OVERLOT GRADING, POND SR4 & UTILITY CONSTRUCTION DOCUMENTS FALCON MARKETPLACE

ISSUE DATE 1ST SUBMITTAL 6-20-17 ESUBMITTAL 6-18-18 DESIGNED BY: DRAWN BY: KGV CHECKED BY:

COVER SHEET

ESIMATED COST OF TEMPORARY + PERMANENT BMPs INCLUDING INSTALLATION AND MAINTENANCE UNTIL FINAL STABILIZATION (FINAL + INTERIM STAGE)

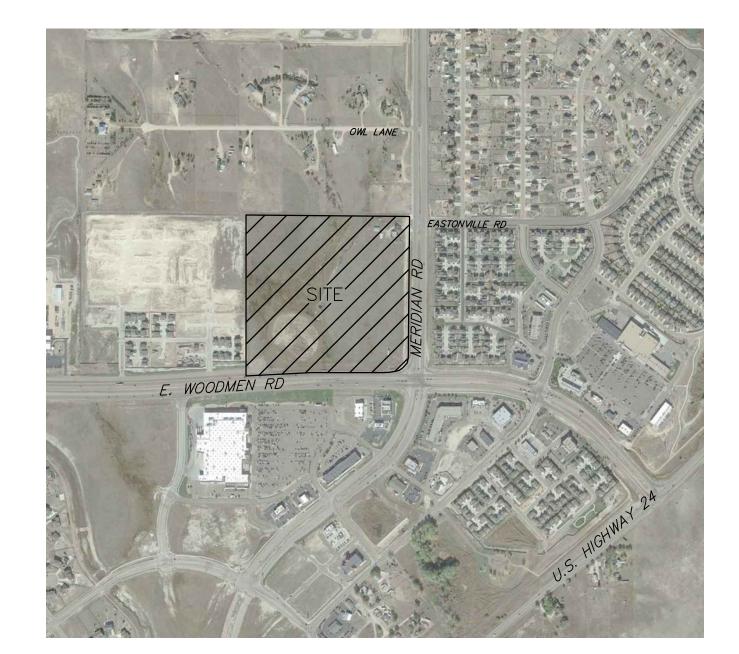
this number seems entirely too low, please proved justification for this value, and show how you got 6250 cy? Please confirm where the clay is coming

> > NOTES

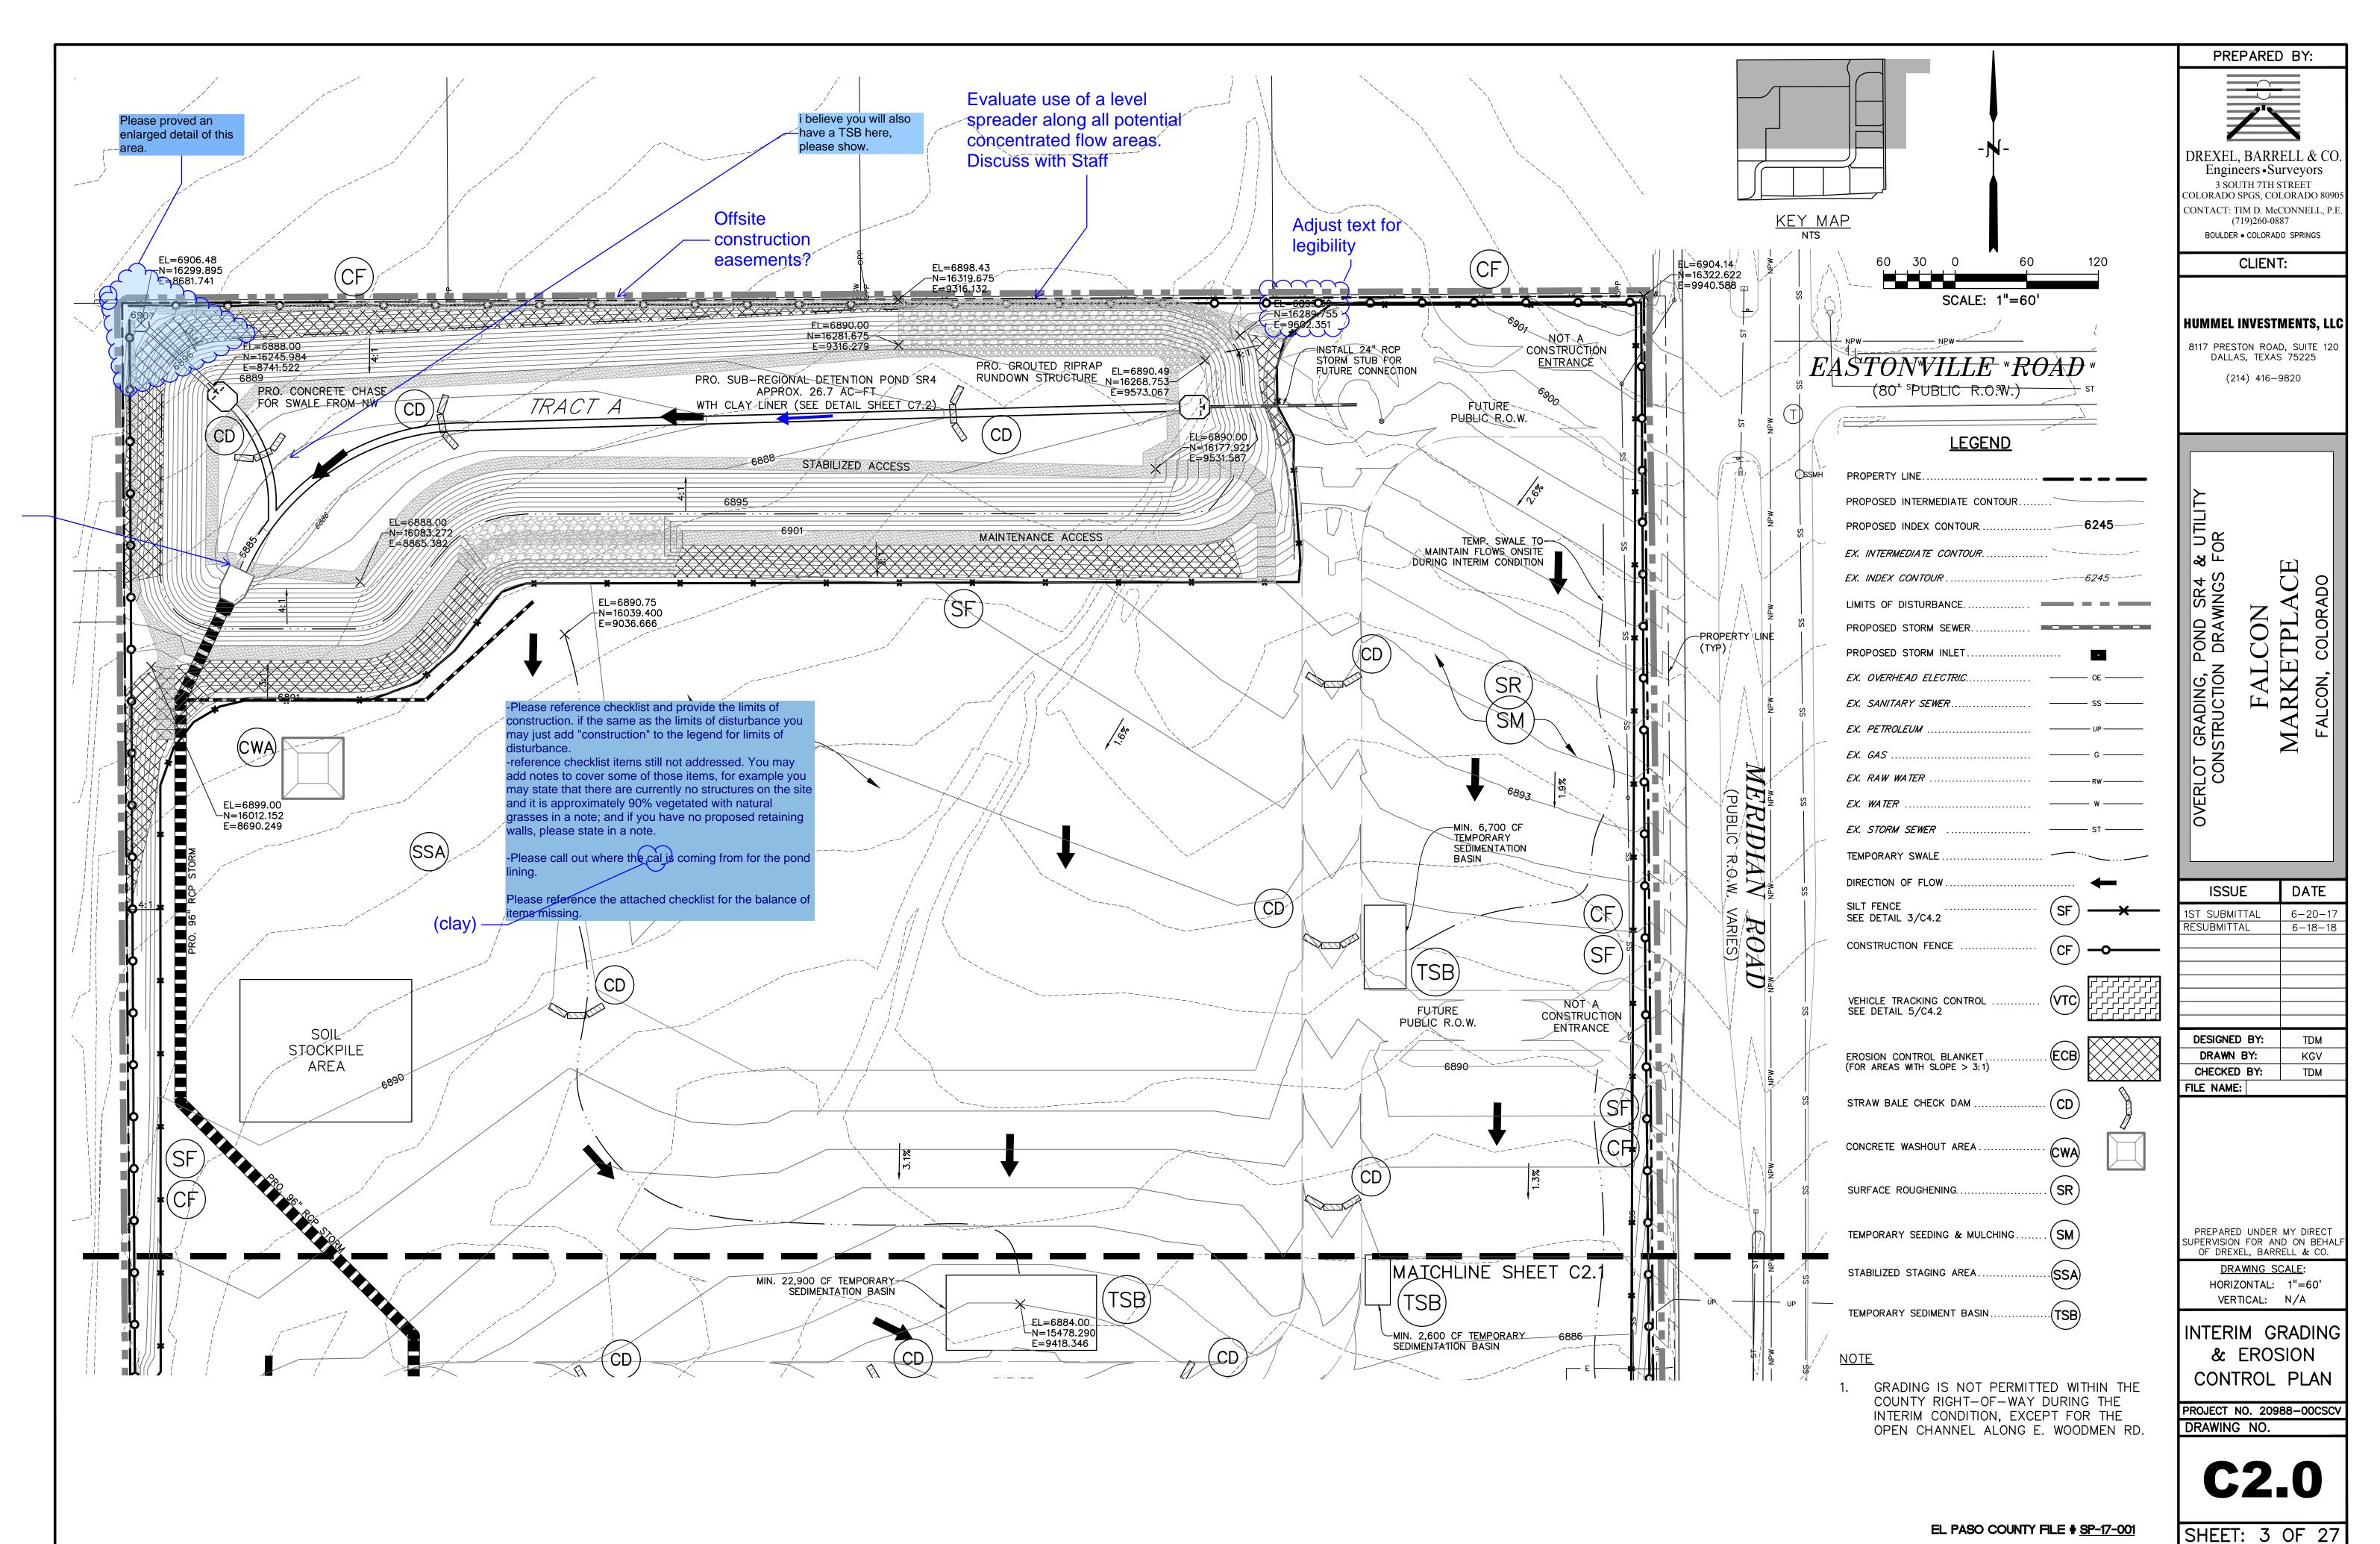
Provide control point

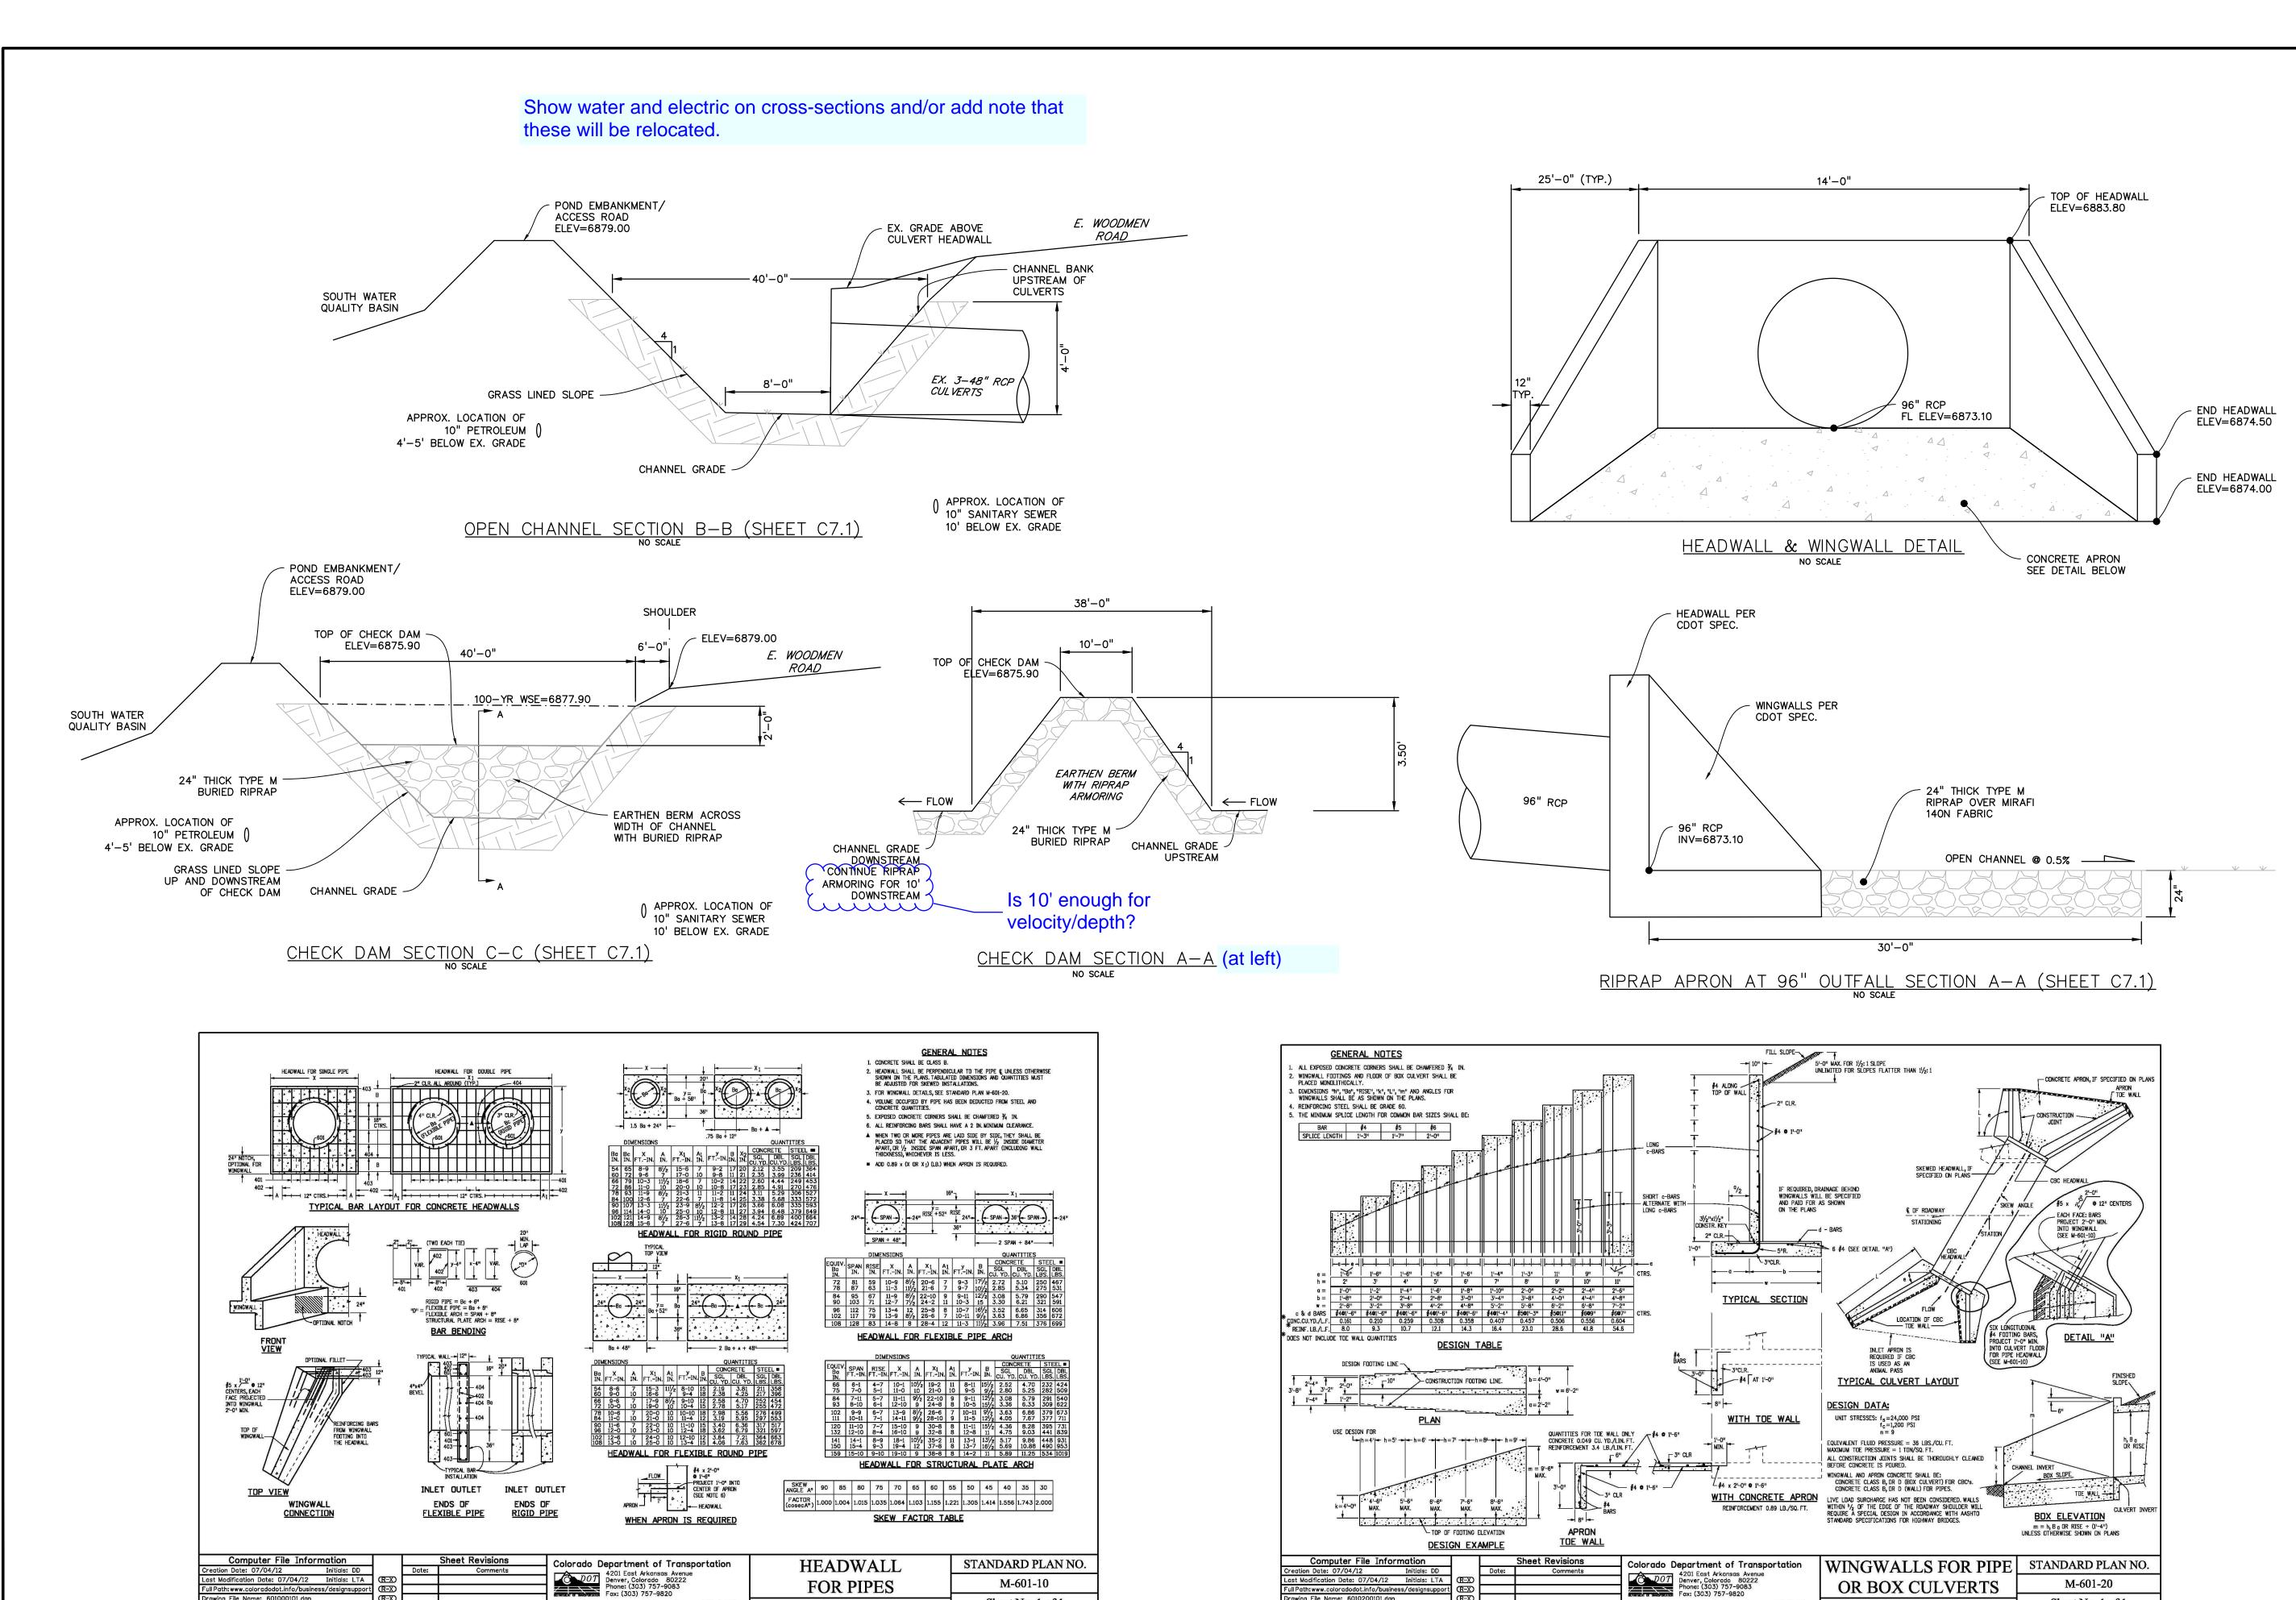
Spec sheet in PDR shows close-mesh. Clarify which type is being used. PREPARED BY: **Detail section** 12 70 X8 0" -CDOT STANDARD MESH CRATE 6893.80 -MODIFIED CDOT _{—96" RCP} dimensions TYPE D INLET 14'-0" OUTLET PIPE C8x18.75 AMERICAN -WOPENING=24" STANDARD STRUCTURAL STEEL CHANNEL. ELEV=6893.80 ELEV=6893.80 DREXEL, BARRELL & CO. Specify gasket WQ WSEL=6893.00 Engineers • Surveyors STRUCTURAL STEEL CHANNEL - FORMED INTO CONCRETE STRUCTURAL STEEL CHANNEL-FORMED INTO CONCRETE 3 SOUTH 7TH STREET 12'-0"X8<mark>'</mark>-0" COLORADO SPGS, COLORADO 8090 TCDOT STANDARD (neoprene or STAINLESS STEEL BOLTS-OR INTERMITTANT WELDS, SEE SECTION B STAINLESS STEEL BOLTS OR-INTERMITTANT WELDS, MESH GRATE CONTACT: TIM D. McCONNELL, P.I equivalent) (719)260-0887 SEE SECTION B BOULDER • COLORADO SPRINGS TRASH RACK ELEV=6890.00 (SEE DETAIL THIS SHEET) CLIENT: ALUMINUM AMICO-KLEMP-19-SR-4 TRASH RACK (1-1/4"X3/16" BAR SPACING) 9.5" DIA. HOLE-PERFORATED PLATE-(1 COLUMN, 3 ROWS) FOR 40 HRS WQCV DRAIN TIME. ELEV=6887.50 (SEE DETAIL THIS SHEET) OR EQUIVALENT F TRICKLE CHANNEL = 6884.83 - HANDRAIL | HUMMEL INVESTMENTS, LLC STORM SEWER ELEV=6885.00 WSE=6884.83 96" RCP 8117 PRESTON ROAD, SUITE 120 DALLAS, TEXAS 75225 NO RESTRICTOR PLATE REQUIRED #4 GR60-@ 12" O.C. 3/8" A36 STEEL ORIFICE PLATE (214) 416-9820 BOTTOM OF MICROPOOL = 6882.00 ELEV=6882.00 ELEV=6882.00 -INV. OUT=6881.87 **ELEVATION** C8X18.75 AMERICAN STANDARD -STRUCTURAL STEEL CHANNEL FORMED INTO CONCRETE BOTTOM AND SIDES OF WOPENING TRASH RACK ATTACHED BY INTERMITTENT WELDS. **ELEVATION** -COMPACTED SUBGRADE (TYP.) PERFORATED PLATE DETAIL TRASH RACK NO SCALE MICROPOOL NO SCALE ELEV⁴6882.00 WELL-SCREEN FRAME ATTACHED TO CHANNEL BY INTERMITTENT WELDS POND OUTLET PROFILE SECTION D-D CON FALCON (ARKETPL) PERFORATED PLATE NOTES: 1. PROVIDE GASKET MATERIAL OR GROUT BETWEEN THE ORIFICE PLATE AND CONCRETE. STAINLESS STEEL-3/8" STEEL — ORIFICE PLATE SUPPORT BARS WELL-SCREEN FRAME 2. BOLT PLATE TO CONCRETE @ 12" MAX. ON CENTER. ORIFICE PLATE IS TO BE REMOVABLE. NO. 93 STAINLESS STEEL -ATTACHED TO CHANNEL 3. ALL METAL SURFACES ARE TO BE COATED WITH ZRC COLD GALVANIZING COMPOUND. BY INTERMITTENT WELDS WOPENING ? - Clarify what will be coated (not stainless steel) FĽOW WOPENING + 4"MIN. SECTION A-A POND OUTLET NO SCALE specify width to SECTION B-E NO SCALE NO SCALE constructability GENERAL NOTES 181/2" . CONCRETE SHALL BE CLASS B. INLET MAY BE CAST—IN—PLACE OR PRECAST. HANDRAIL - WELDED 2"ø GALVANIZED DATE **ISSUE** -CDOT STANDARD 2. SEE PLANS FOR SIZE AND LOCATION OF PIPE. SCH 40 STEEL TUBING MESH GRATE STRUCTURAL STEEL FOR GRATES AND GRATE INSTALLATION 1ST SUBMITTAL 6-20-17 HARDWARE SHALL BE GALVANIZED AND SHALL BE IN ACCORDANCE WITH SUBSECTION 712.06. POST SPACING 10' O.C. SLOT DETAIL ESUBMITTAL 6-18-18 STANDARD INLET GRATES SHALL BE USED ON ALL TYPE D INLETS UNLESS CLOSE MESH GRATES ARE SPECIFIED ON THE PLANS. 5. STEPS SHALL BE PROVIDED WHEN INLET DIMENSION "H" IS EQUAL TO OR GREATER THAN 3 FT.-6 IN. AND SHALL CONFORM WITH AASHTO M 199. – 👆 🏿 6" Walls and Floor (Typ.) 🖔 REINFORCING BARS SHALL BE EPOXY COATED AND DEFORMED #4, AND SHALL HAVE A 2 IN. MINIMUM CLEARANCE. CUT OR BEND BARS AROUND PIPE AS REQUIRED. TRANSVERSE CROSS SECTION LONGITUDINAL CROSS SECTION INLET WALL ALTERNATE SLOT LEVEL GRATE INSTALLATION AND HOLD DOWN
